P&ID
MAKE-UP DEMINERALIZER (WM)
WM H ZIMMER NUCLEAR POWER STATION UNIT 1
THE CINCINNATI GAS & ELECTRIC COMPANY
COLUMBUS & SOUTHERN OHIO ELECTRIC COMPANY
THE DAYTON POWER AND LIGHT COMPANY

DRAWING NO.
M-34 Sht. 2
M-34-2

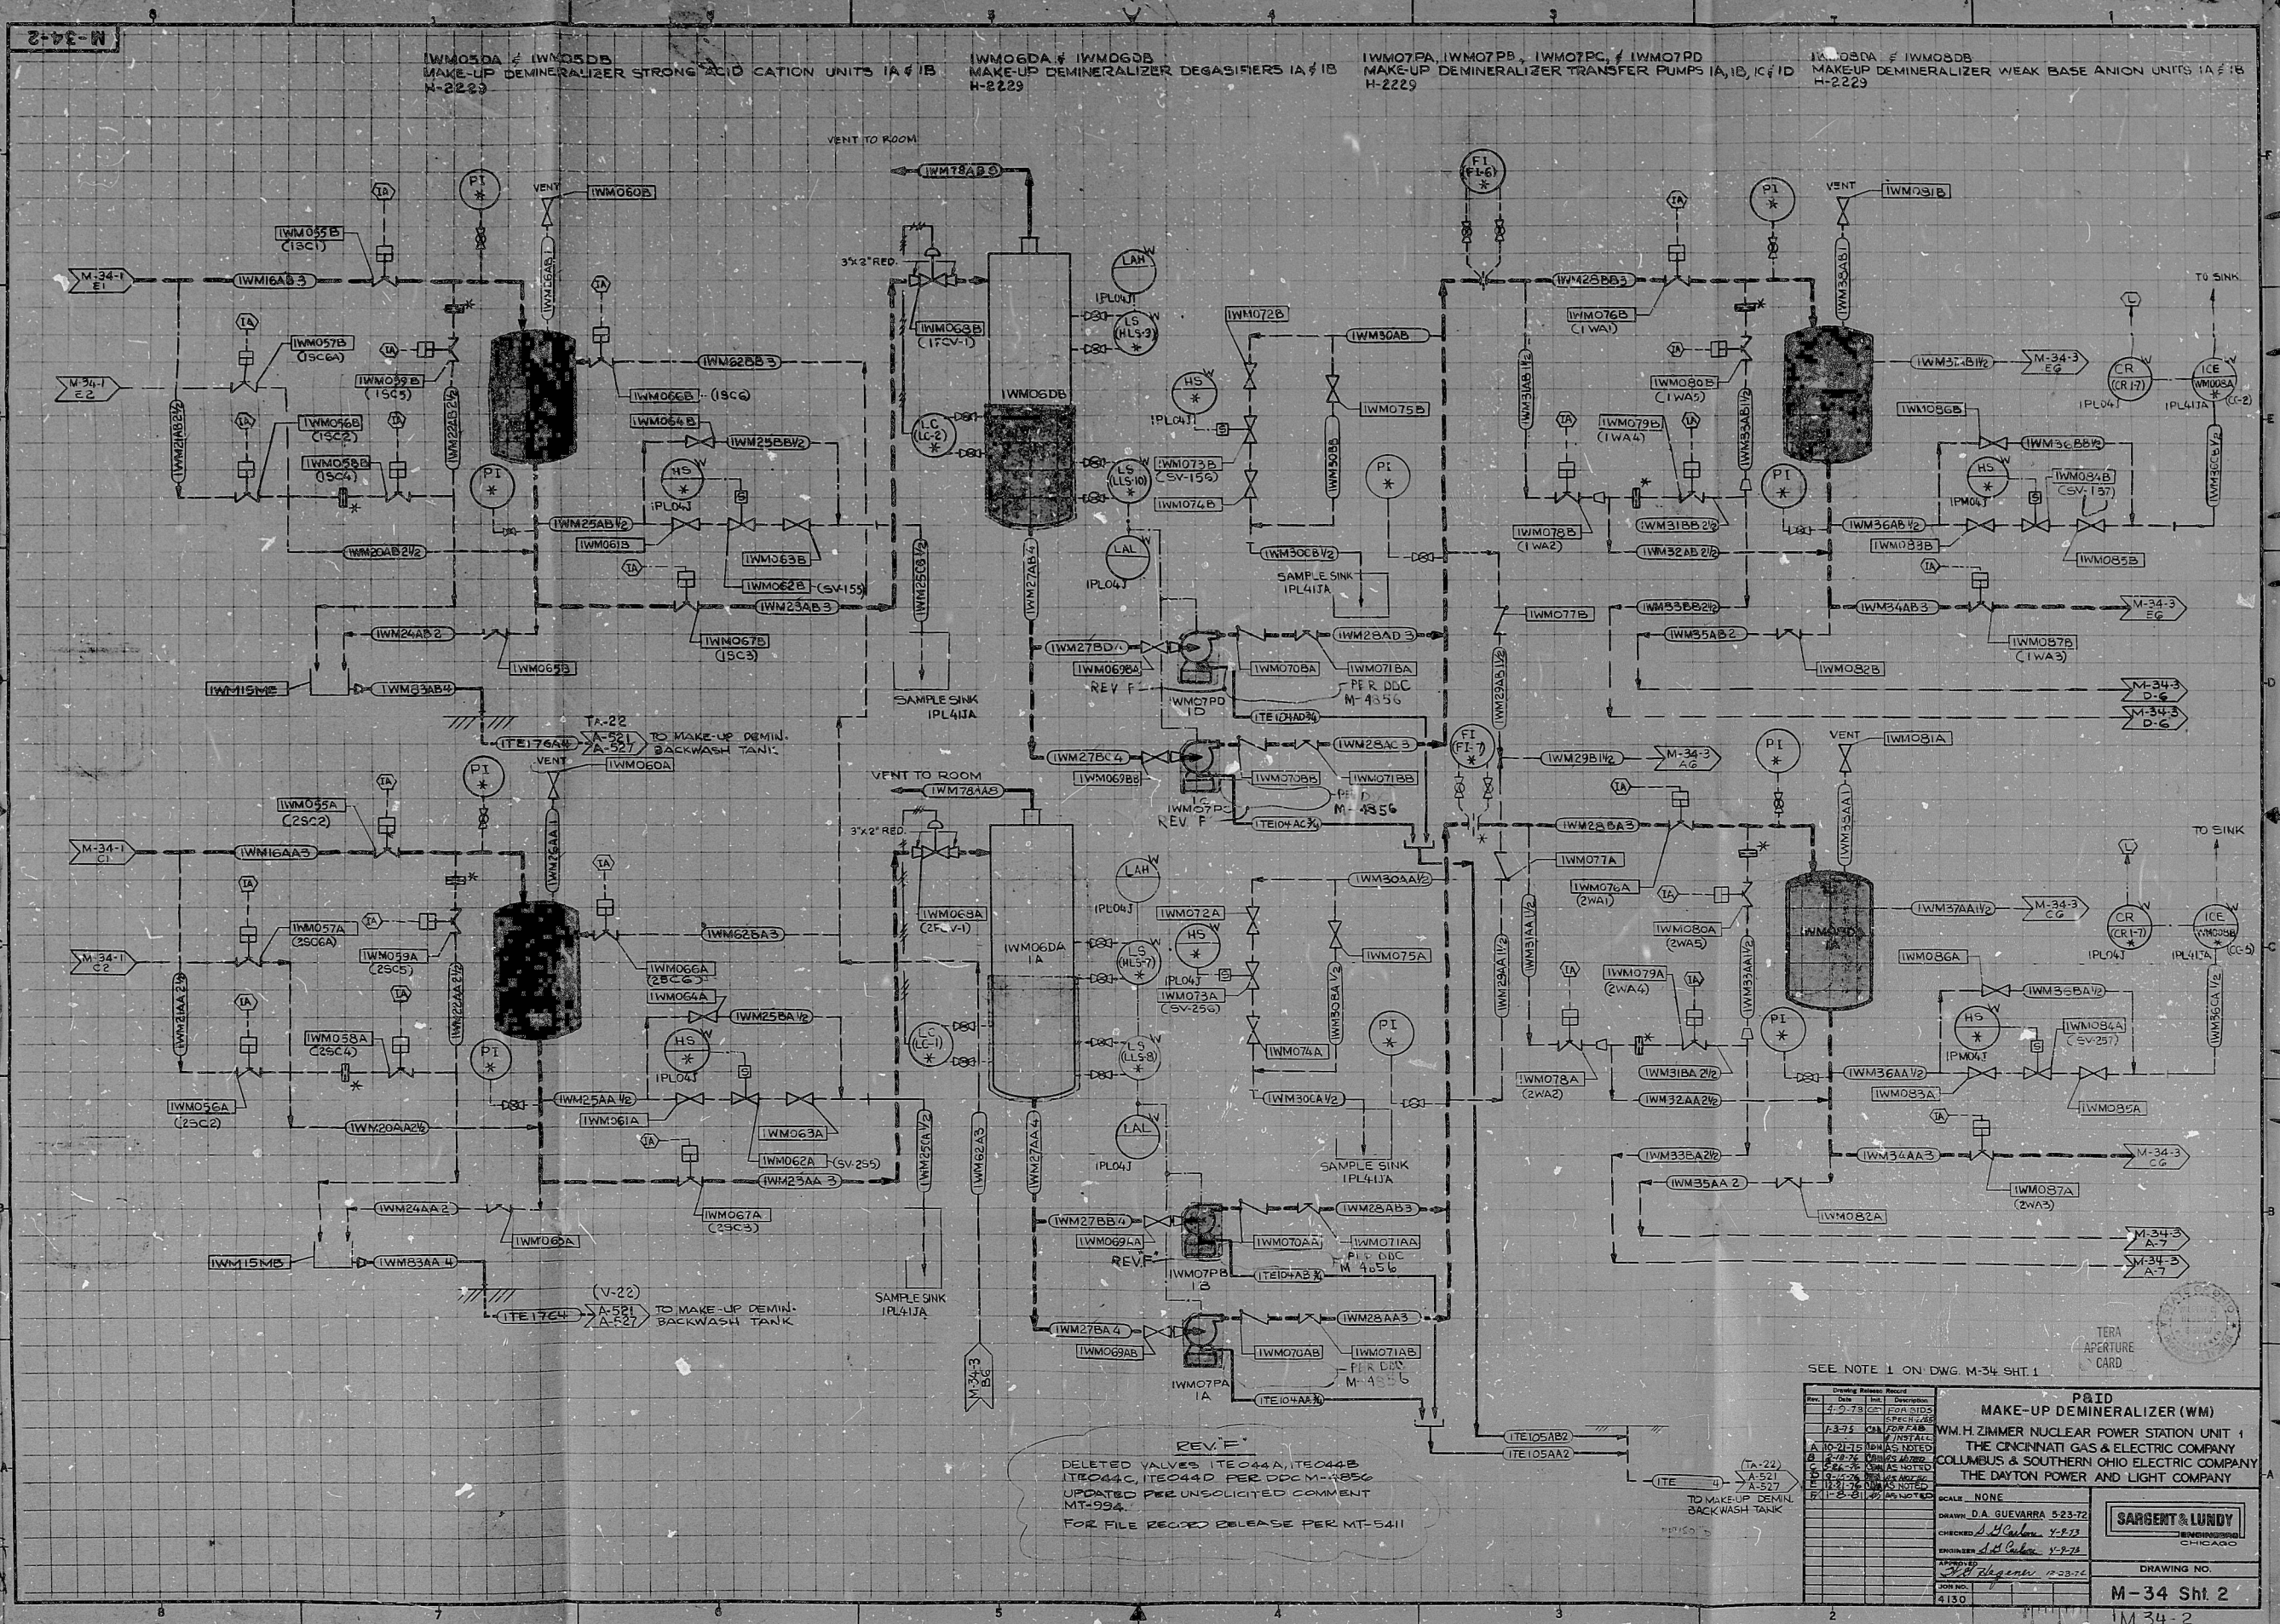
REV F
DELETED VALVES ITC44A, ITC44B
ITC44C, ITC44D PER DDC M-4856
UPDATED PER UNSOLICITED COMMENT
MT-994.
FOR FILE REQ'D RELEASE PER MT-5411
